REMEDIATION SYSTEM EVALUATION (RSE)

PENTA WOOD PRODUCTS SITE

DANIELS, WISCONSIN

Report of the Remediation System Evaluation
Site Visit Conducted October 12, 2005

Figure 1-2 EXTENT OF PCP GROUNDWATER CONTAMINATION 2004

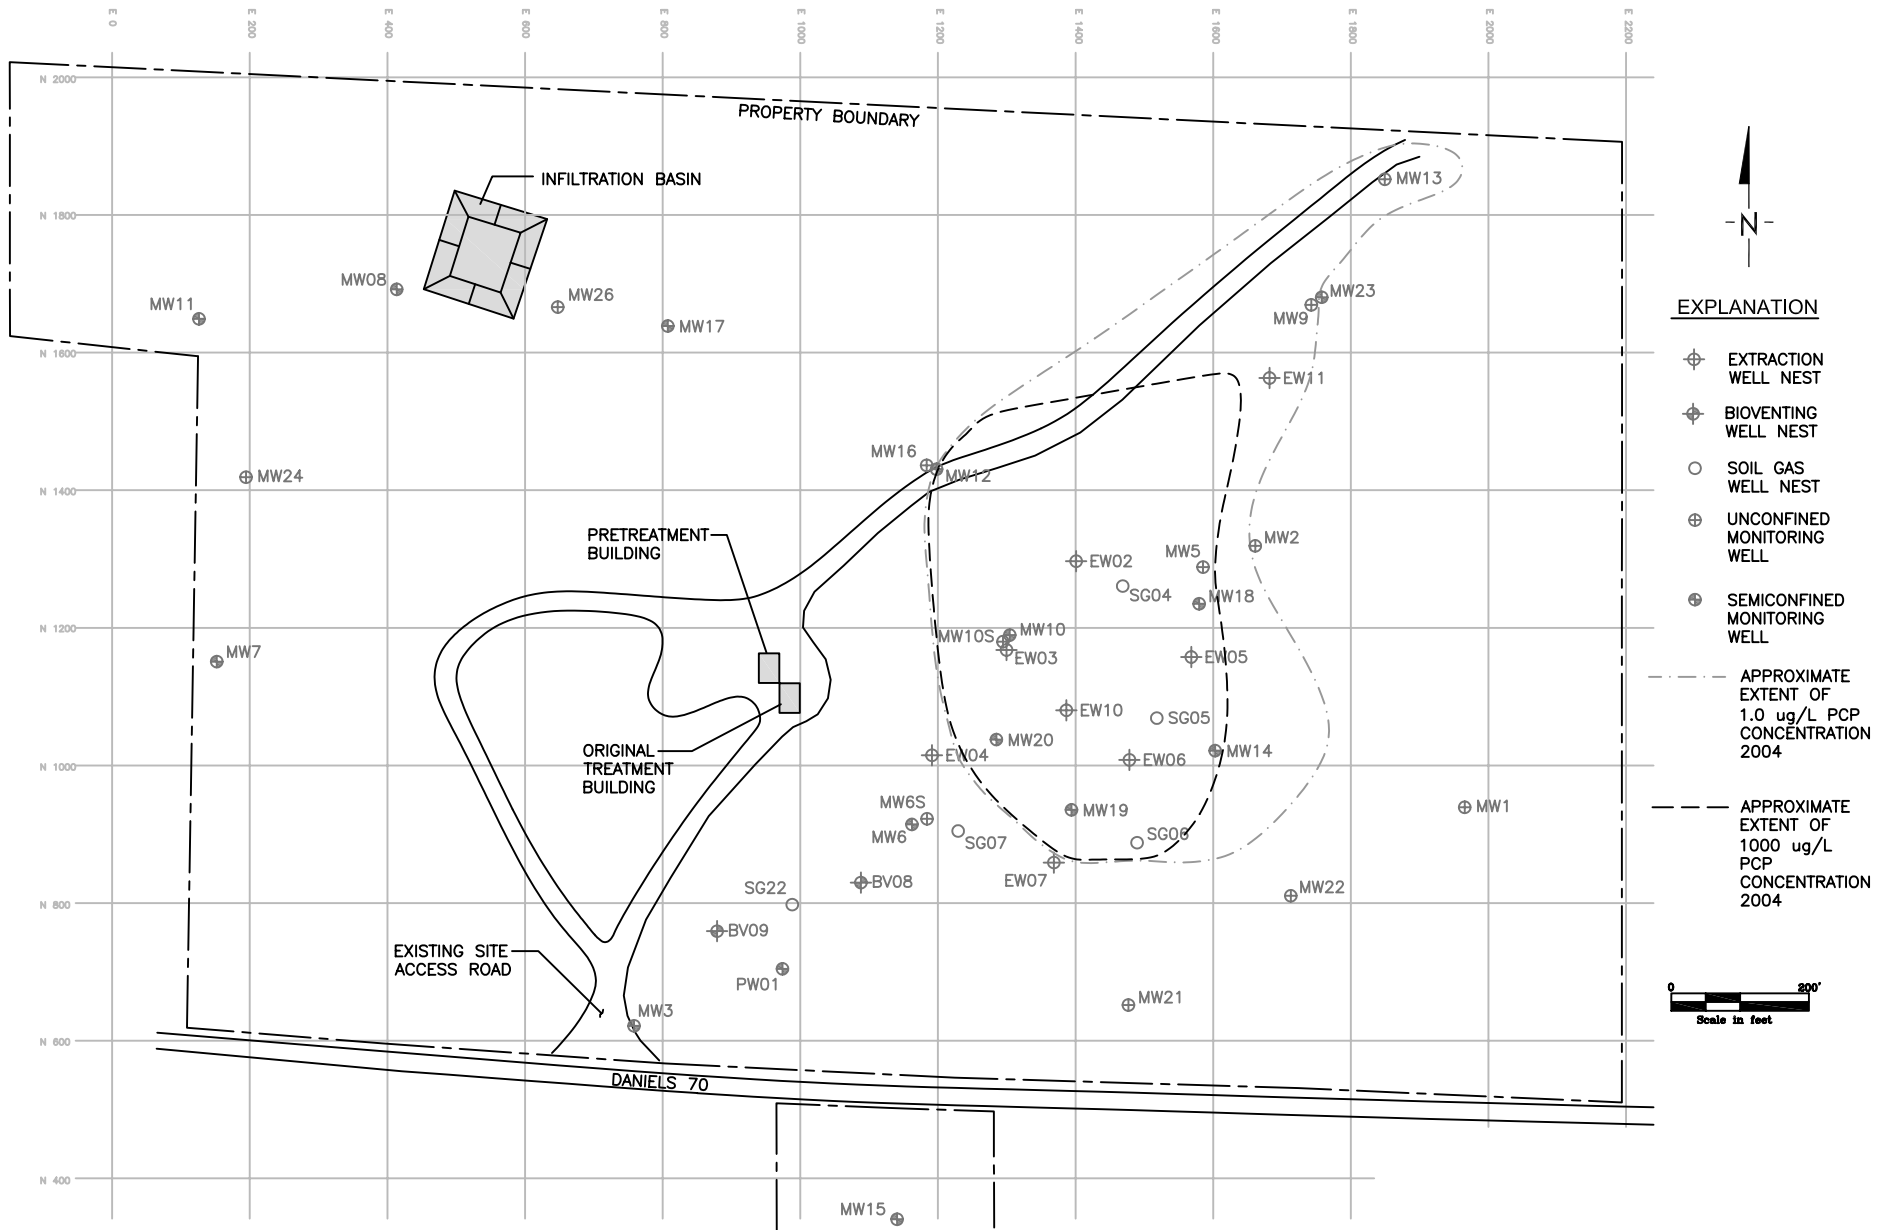
below 1 ug/L. However, there are a few exceptions. Most notable is the detection of PCP at 2.9 ug/L and 4.67 ug/L in MW-13 in 2003 and 2004, respectively. This increase, if statistically significant and not the result of cross contamination from other samples, could indicate that the plume is migrating to the northeast.

The 2003 and 2004 increases in PCP concentrations for MW-13 suggest that the PCP plume might be expanding toward the northeast. Additional years of monitoring data will help confirm if the plume is expanding. The current system is not designed to provide hydraulic containment, so it is possible for the system to operate as intended and for the plume to potentially expand. The migration toward MW-13 is away from residences with potable wells but is toward wetlands and lakes to the northeast of the property. The remedy currently appears to be protective of human health and the environment but future monitoring will need to be evaluated to determine if the remedy will be protective over the long-term.

The potential migration evidenced by increased PCP concentrations in MW-13 suggests the need to continue to closely evaluate the concentration trends in this well to determine if plume migration is occurring. It is recommended that the site team continue to closely follow the sampling data from this and other monitoring wells to evaluate the potential for plume migration. These monitoring wells represent the only source of information that will provide evidence of migration before residential wells or ecological receptors are impacted. If continued increases are observed in MW-13, the site team may want to consider installing a monitoring well approximately 300 feet east of MW-13 (if access is available) to monitor potential migration in this direction. If data suggests that migration is occurring in the direction of the residences, a more thorough capture zone analysis is likely merited to determine if pumping needs to increase to prevent migration and protect these wells.
